The Commission has issued the enclosed Amendments Nos. 34, 34 and 31 for Licenses Nos. DPR-38, DPR-47 DPR-55 for the Oconee Nuclear Station, Units Nos. 1, 2 and 3. These amendments consist of changes to the station Technical Speicifications and are in response to your request dated July 21, 1976, as supplemented August 28, October 7, October 19, October 20, and October 20, 1976.

DUKE POWER COMPANY

OCONEE NUCLEAR STATION, UNIT 1

Amendment No. 34
License No. DPR-38

Figure 3.5.2-1C1
Amendments Nos. 34, 34 & 31

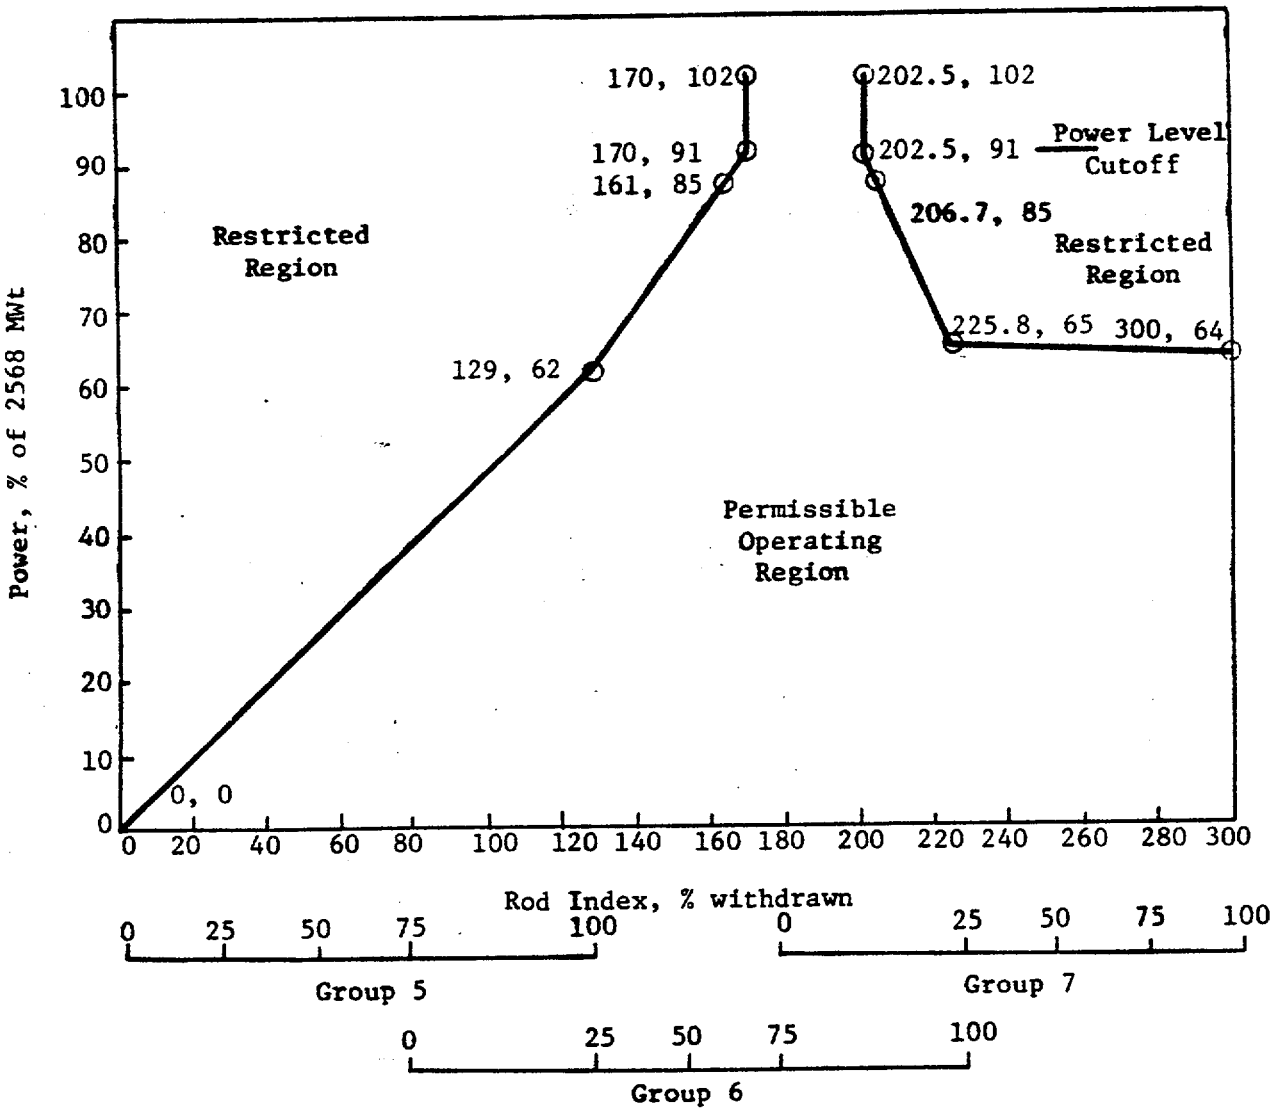
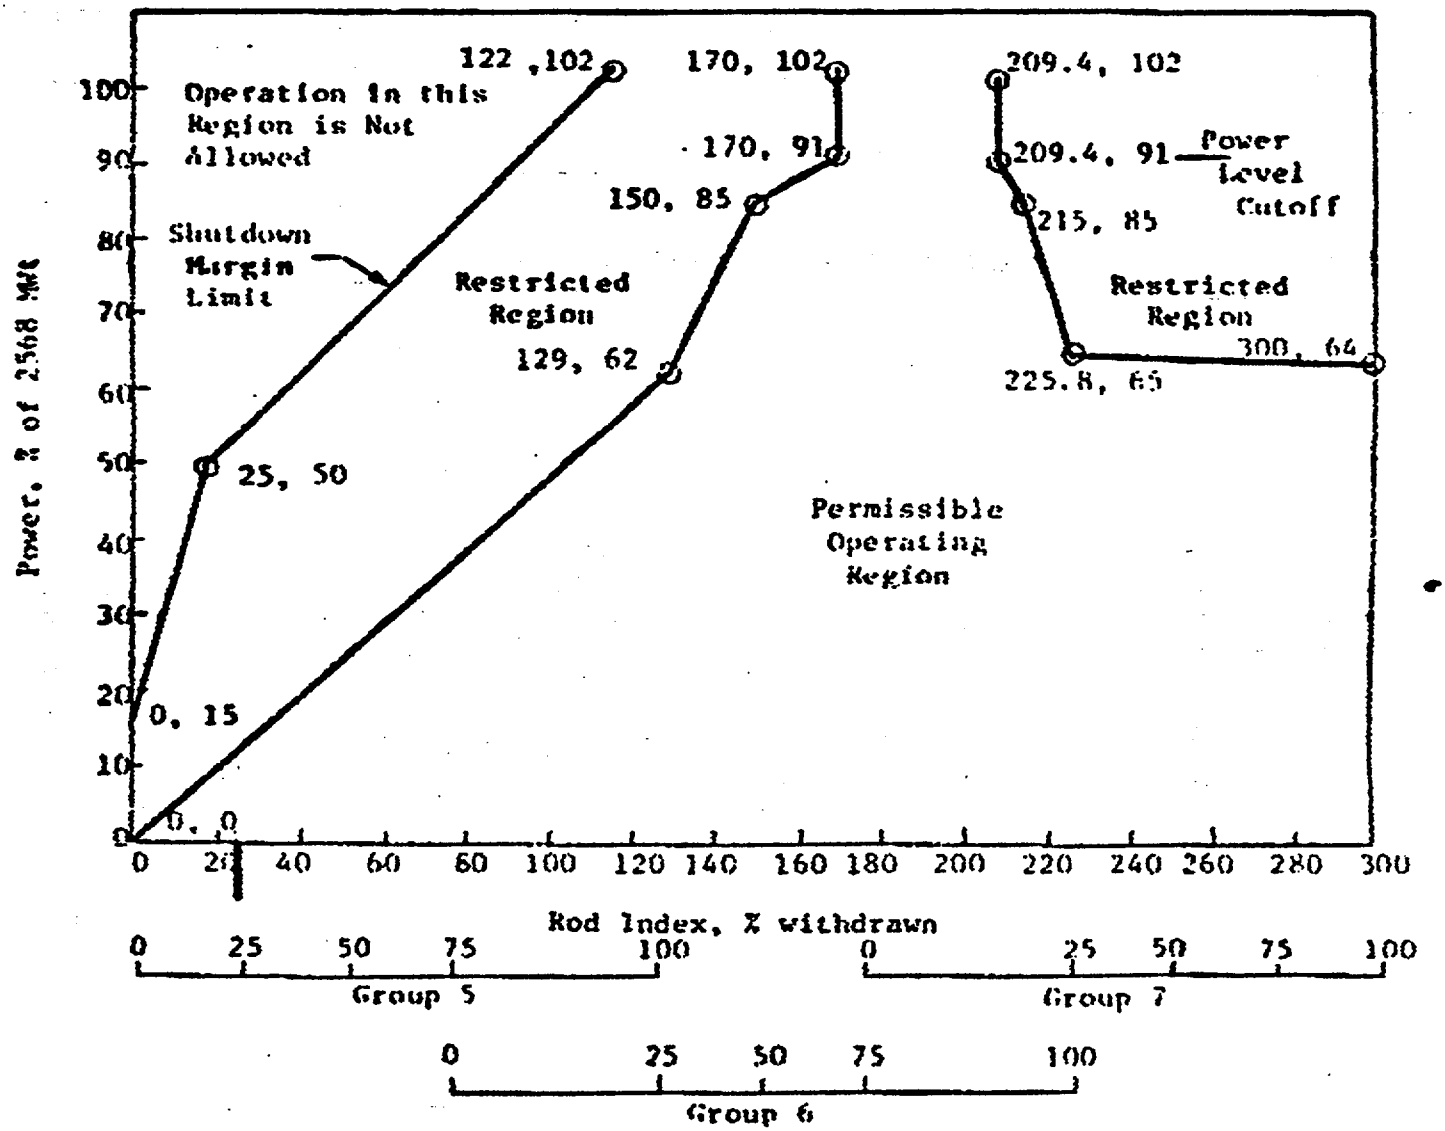
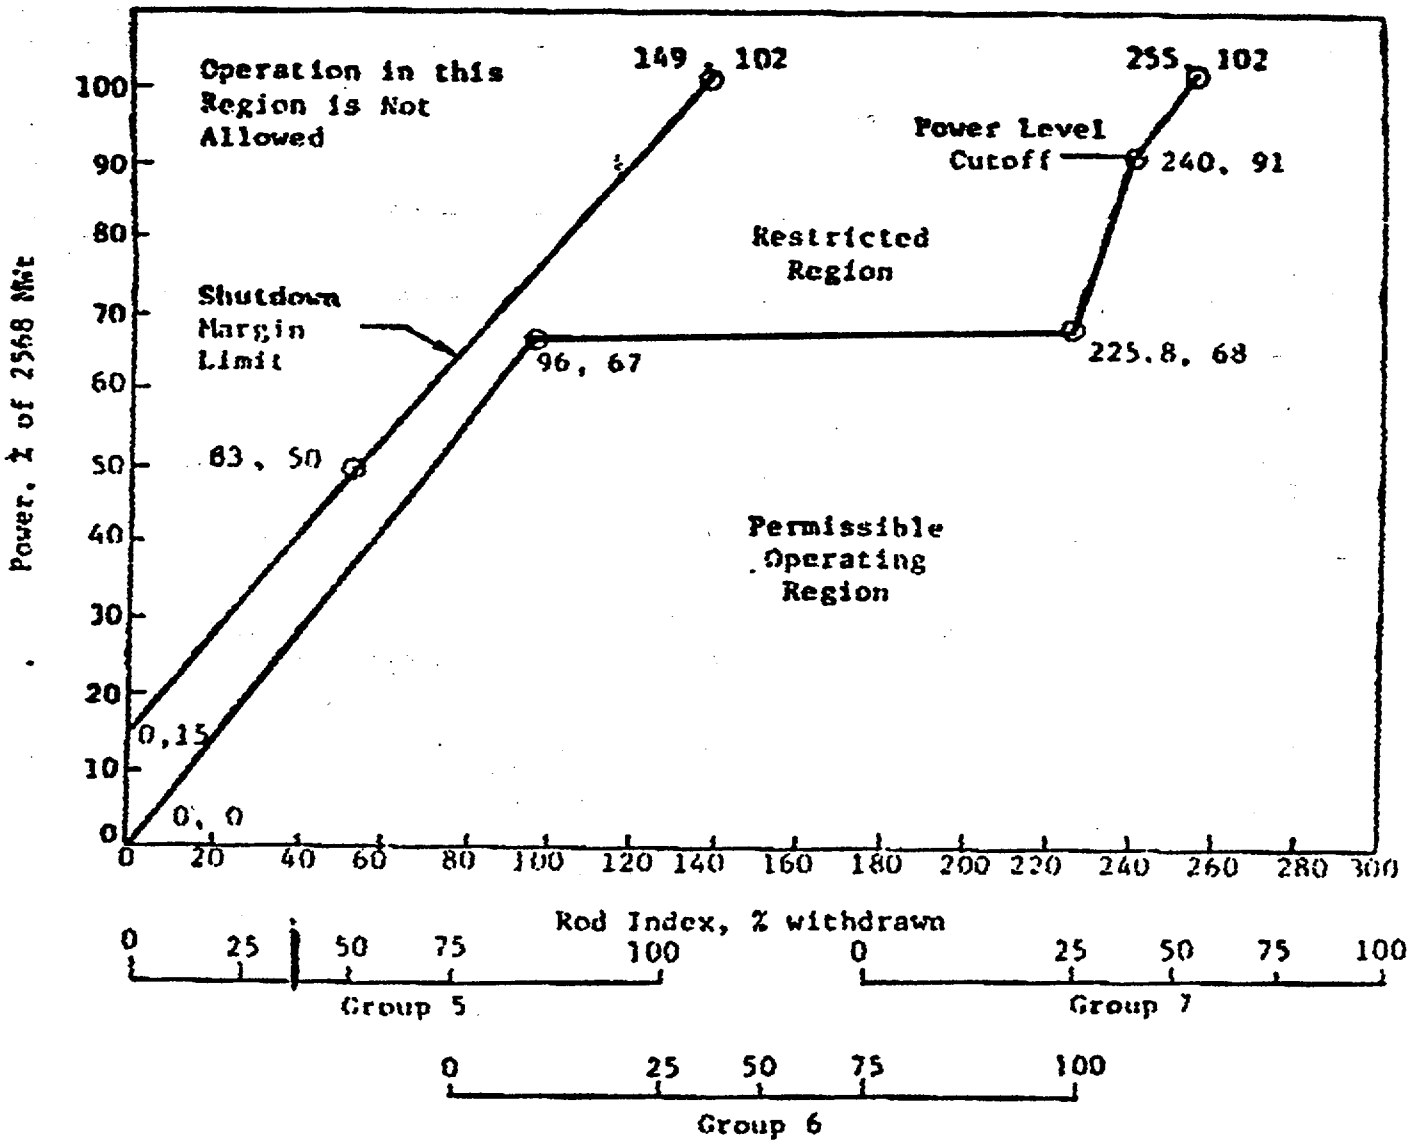
d. Except for physics tests, power shall not be increased above the power level cutoff as shown on Figures 3.5.2-1A1, 3.5.2-1A2 (Unit 1), 3.5.2-1B1, 3.5.2-1B2, and 3.5.2-1B3 (Unit 2), and 3.5.2-1C1, 3.5.2-1C2, 3.5.2-1C3 (Unit 3), unless the following requirements are met.

Figure 3.5.2-2C1

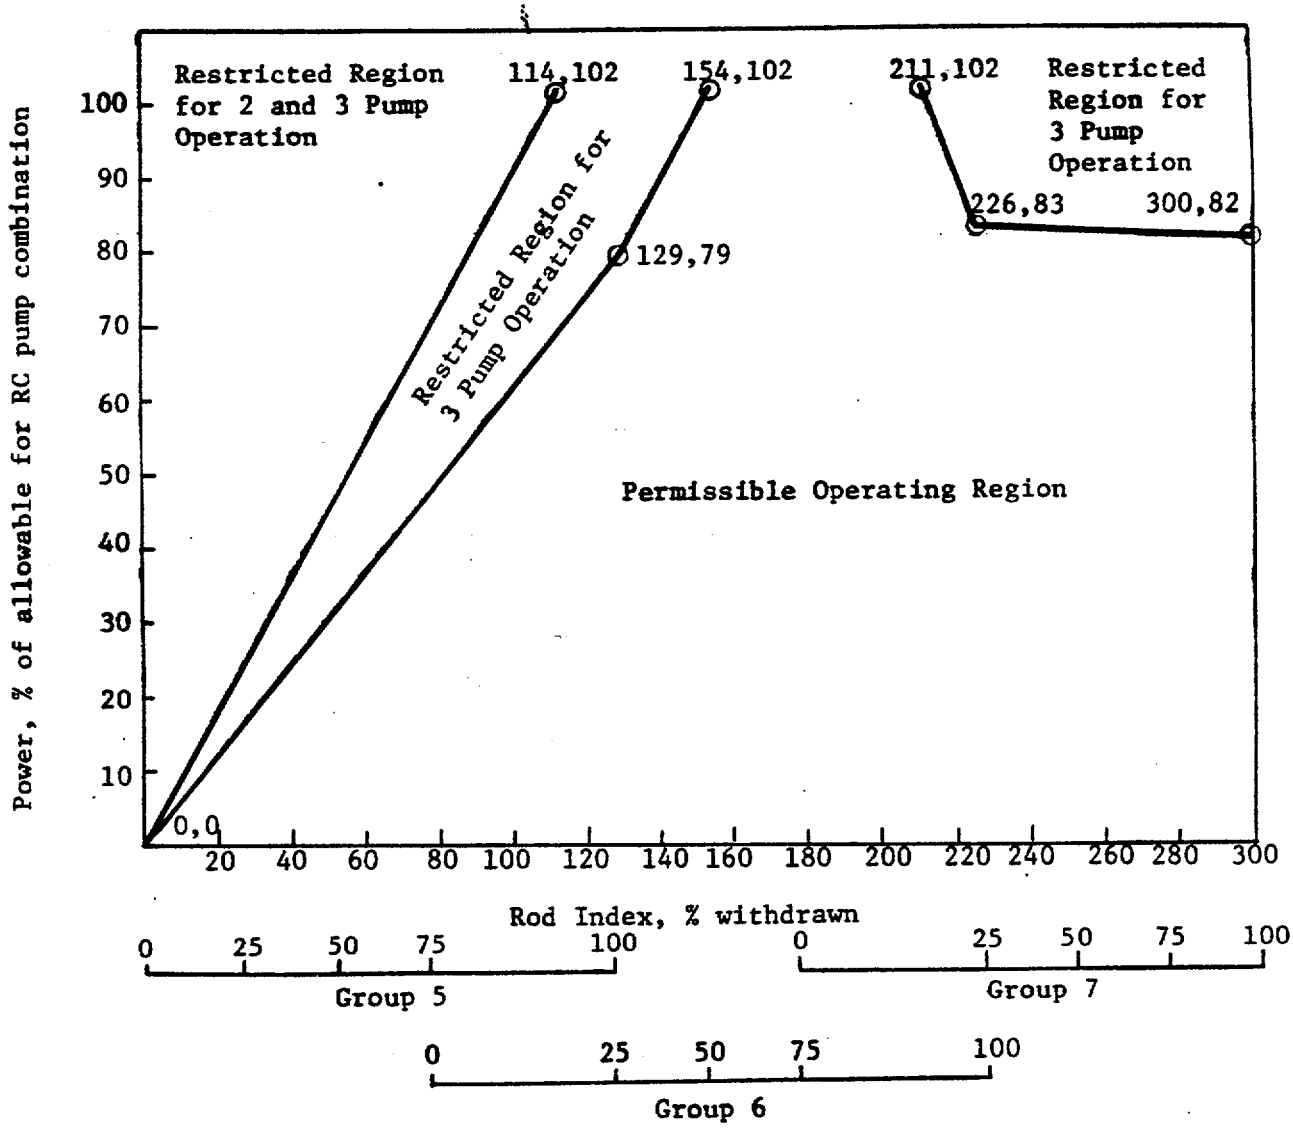
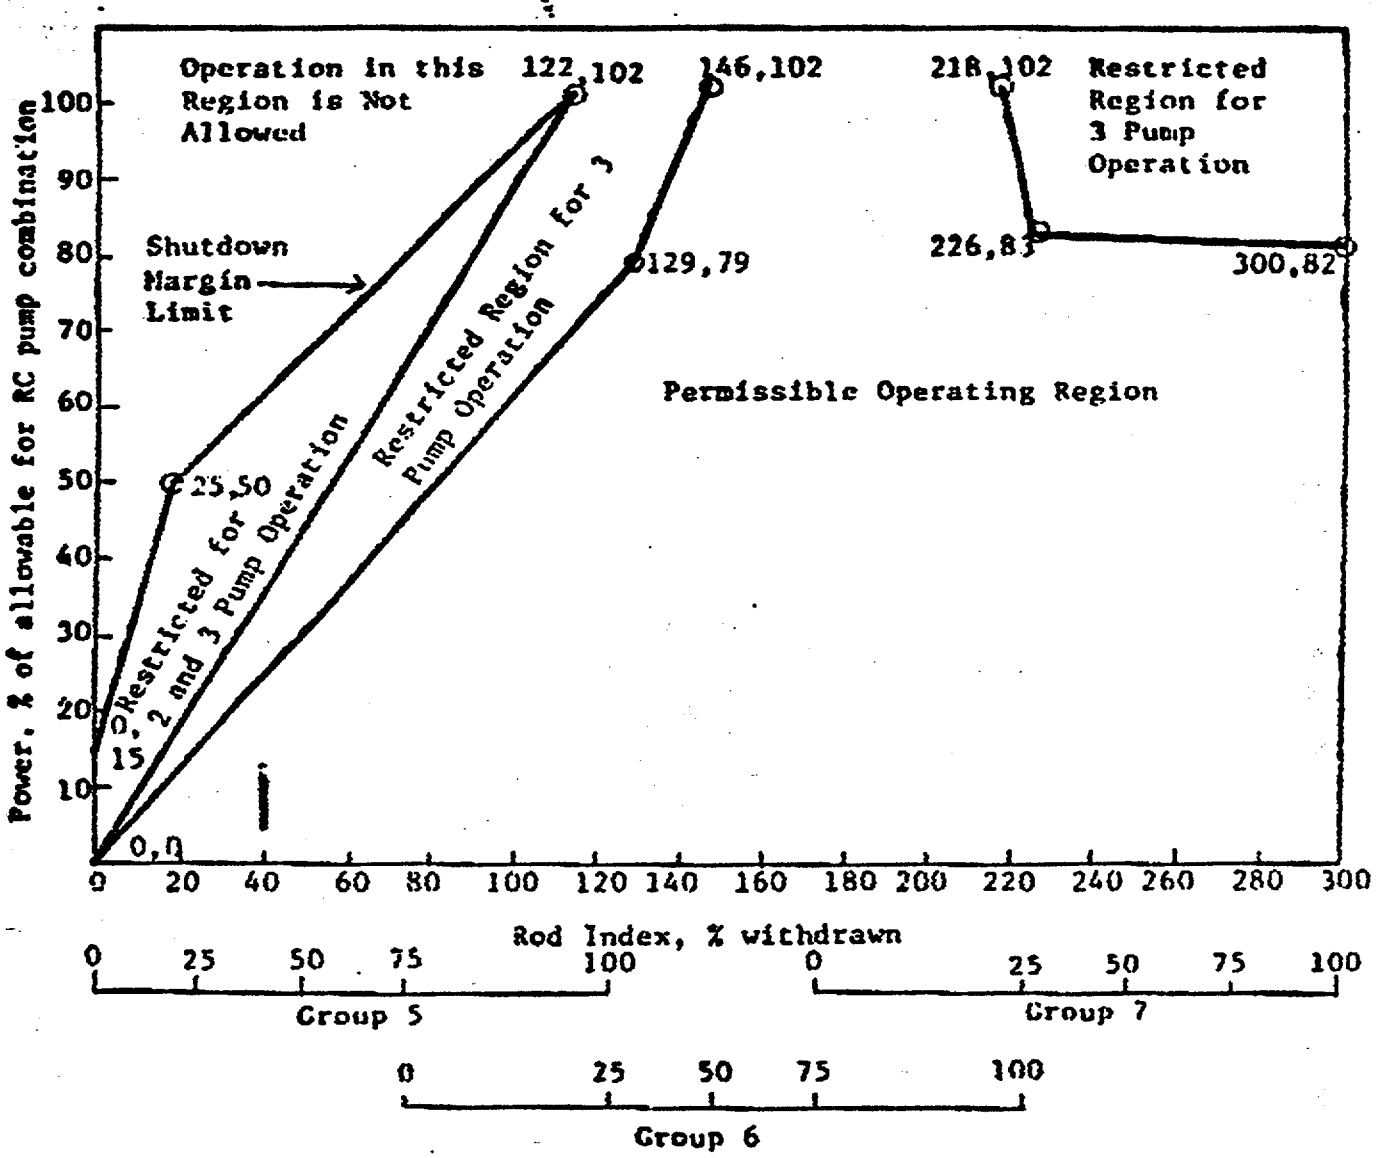
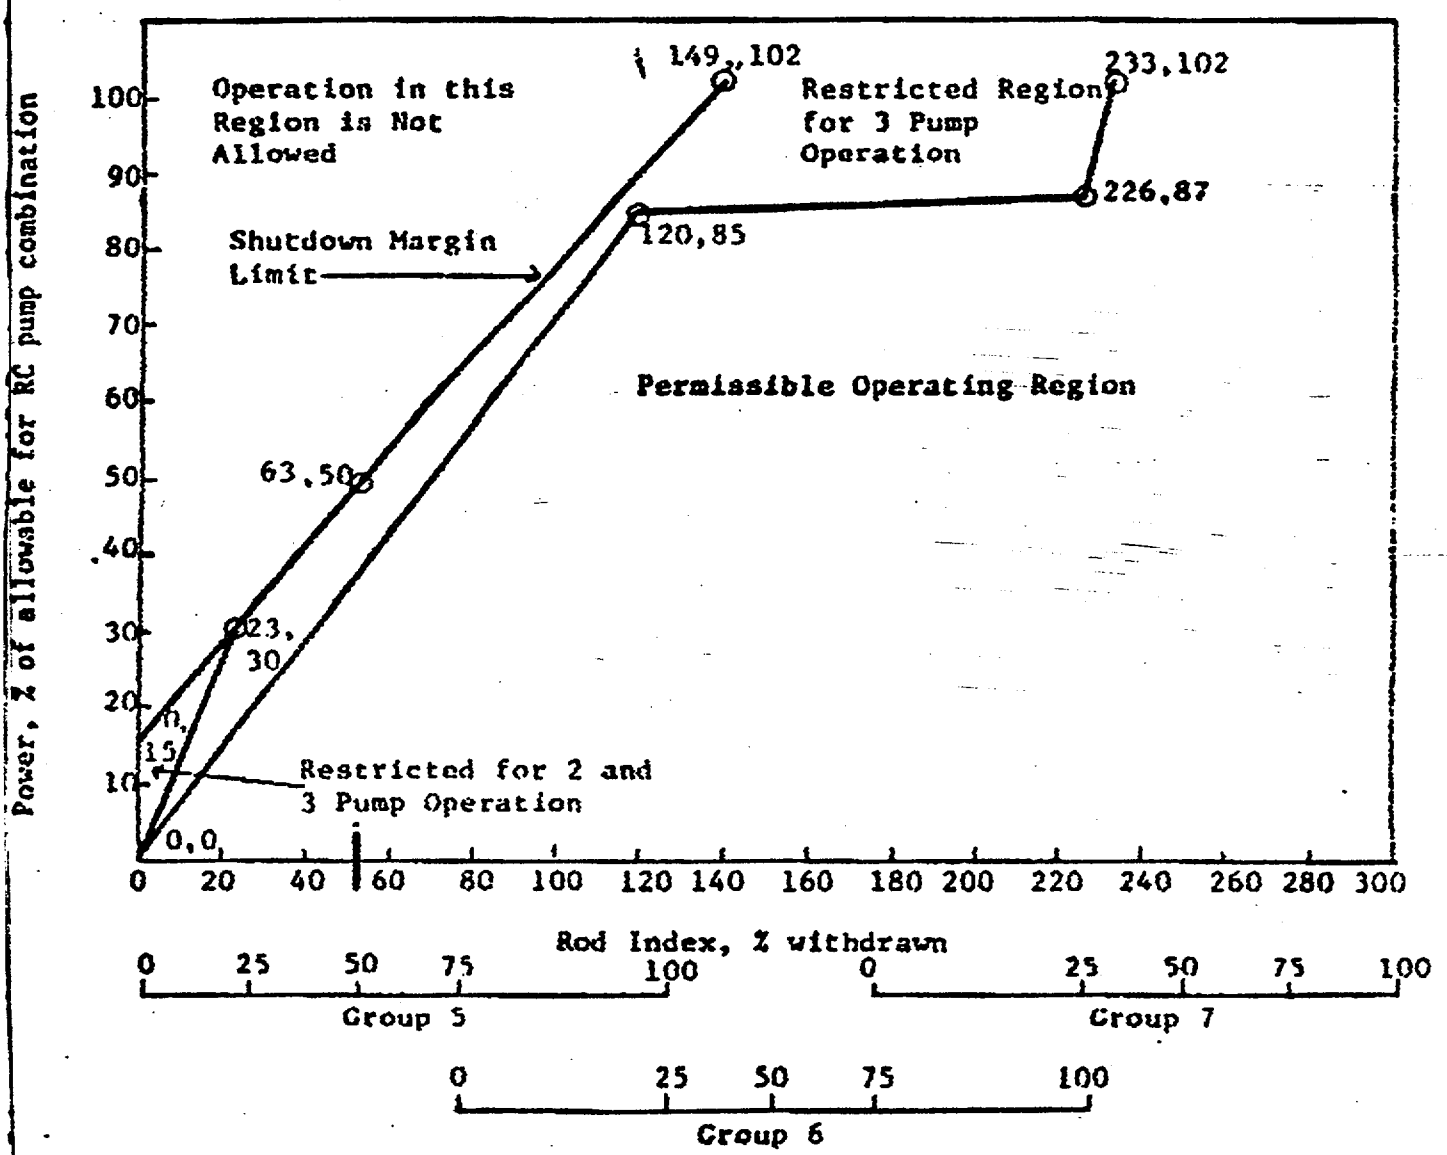
c. Except for physics tests or exercising control rods, the control rod withdrawal limits are specified on Figures 3.5.2-1A1 and 3.5.2-1A2, (Unit 1), 3.5.2-1B1, 3.5.2-1B2 and 3.5.2-1B3 (Unit 2), and 3.5.2-1C1, 3.5.2-1C2, and 3.5.2-1C3 (Unit 3) for four pump operation and on Figures 3.5.2-2A1, 3.5.2-2A2 (Unit 1), 3.5.2-2B1, 3.5.2-2B2 and 3.5.2-2B3 (Unit 2), and 3.5.2-2C1, 3.5.2-2C2, and 3.5.2-2C3 (Unit 3) for three or two pump
